In Reply Refer To:
HSST-1/B-40B

Decision

- Narrow QuickChange Moveable Barrier QMB modifications

Name of system:	Narrow QuickChange Moveable Barrier modifications
Type of system:	Portable / Moveable Longitudinal Barrier
Test Level	NCHRP Report 350 TL-3
Date of original request:	December 23, 2015
Original FHWA letter:	B-40 dated August 27, 1997
FHWA Control number:	B-40B

Oversized hole

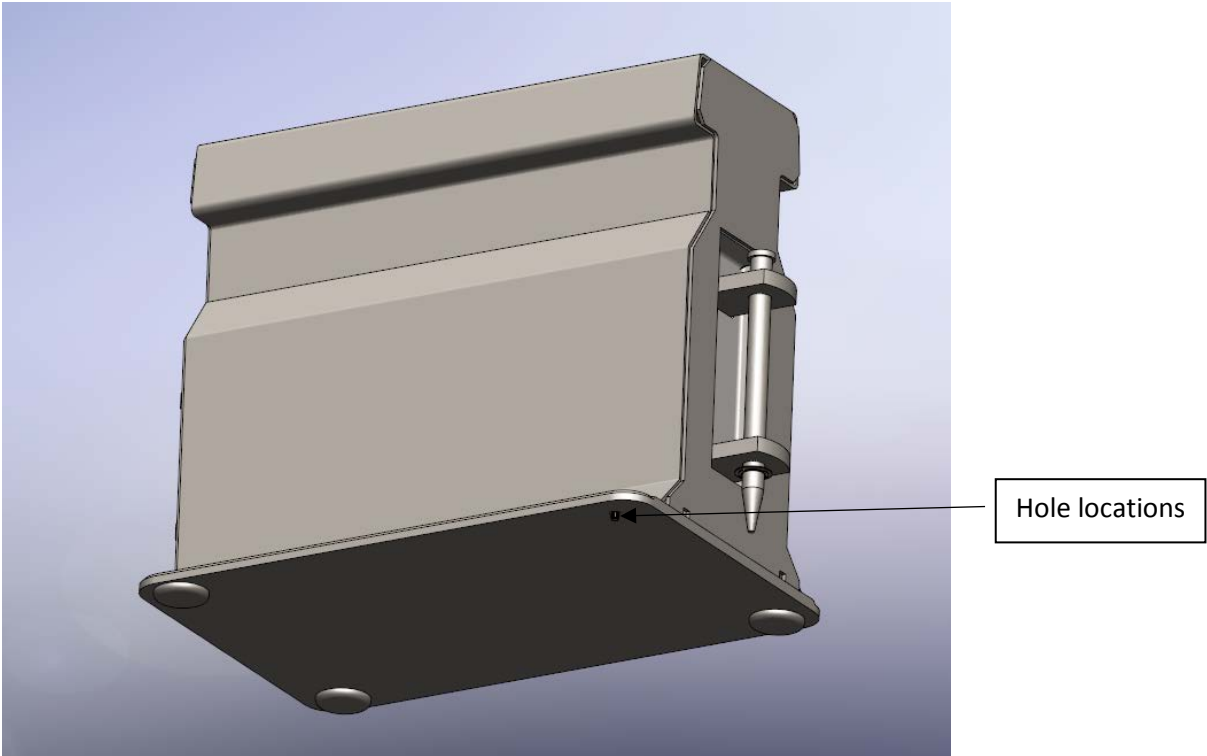
1) Each Narrow QMB barrier element is equipped with 4 rubber feet that are attached to the barrier through clearance holes at the four corners of the base-plates. The holes are slightly larger than what is required for the 1/2" bolts connecting the feet. As a result, there is the potential for the bolts to work themselves loose over time due to excess wiggle room. This request is for the acceptance of a slight reduction to the diameter of the clearance holes in the base-plates. This modification represents no change to the function, capacity or performance of the barrier element or the longitudinal barrier system as a whole.

New clip is shown on the left and the old clip on the right.

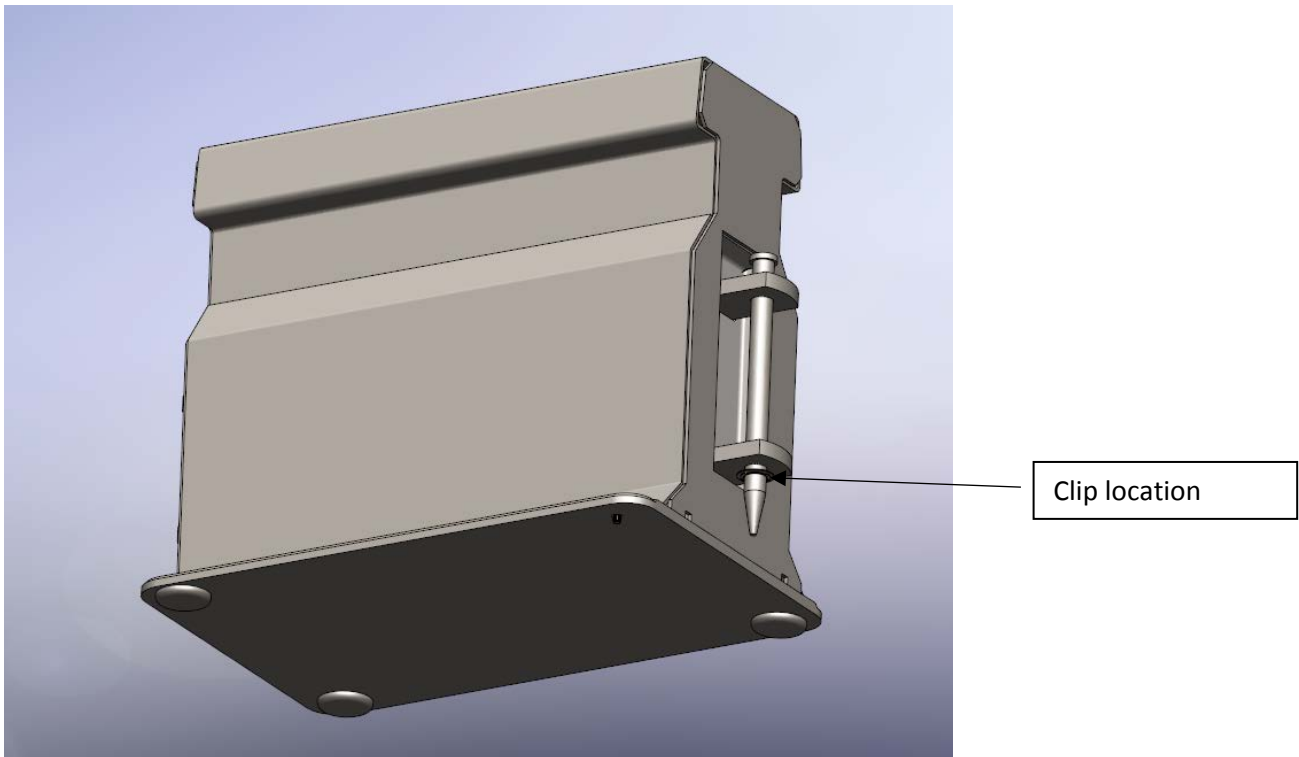
2) All Narrow QMB barrier elements are pinned together using a large 1-3/8" diameter pin. The pins have a small groove receiving a retaining clip that prevent the pins from working themselves out during the barrier transfer. Over the years a number of clips have fallen off. The failures are believed to be caused by fatigue. A stronger clip/washer configuration has been identified and proven to be up to 10 times more durable in bench testing. This request is for the acceptance of an alternative retaining clip. The clip does not come into play during crash testing, therefore this modification represents no change to the function, capacity or performance of the barrier element or the longitudinal barrier system as a whole.

New Pusher Plate on the left

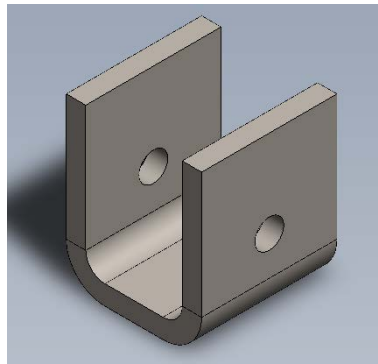
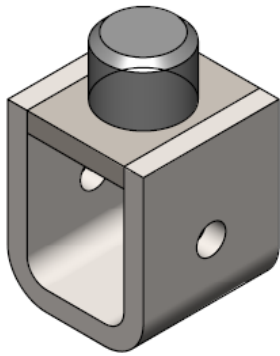
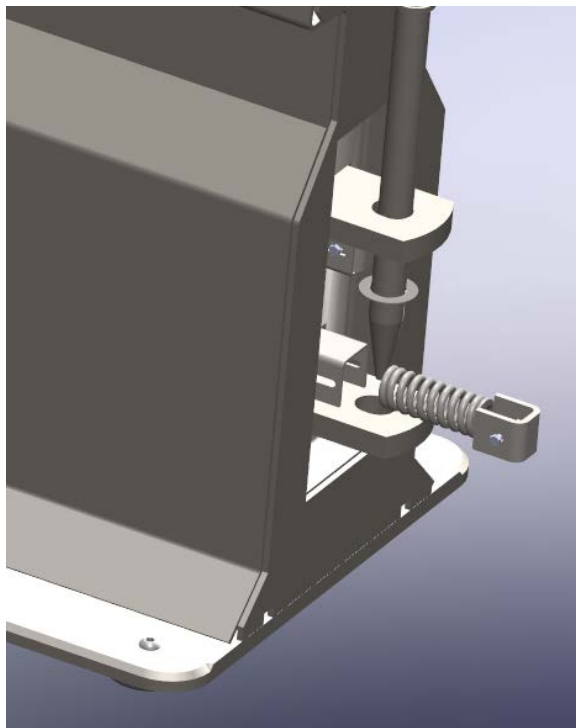
3) There are two springs at each joint where the pins connect the Narrow QMB barrier elements. These springs apply pressure on the pins connecting the barriers such that any slop in the hinges is removed and the barriers are always in tension (this is how the barrier gets its Reactive Tension designation). Having the barriers in tension helps reduce the deflection of the barrier wall during a crash. The springs sit in a mild steel housing and push against a "U" shaped plate that pushes against the pin. Over the years it was noticed that some springs have the potential of wearing a groove in the spring housing and occasionally get snagged in this groove such that they no longer apply pressure on the pin. A new "U" shaped plate was developed that has a small cylindrical rod welded to its ends. This rod keeps the spring centered in the spring housing preventing it from wearing out the spring. This new "pusher plate" can be used on new barriers going forward as well as to retrofit old barriers that were damaged by a wondering spring. The pusher plate is centrally located between the barriers and does not come into play during crash testing, therefore this modification represents no change to the function, capacity or performance of the barrier element or the longitudinal barrier system as a whole.
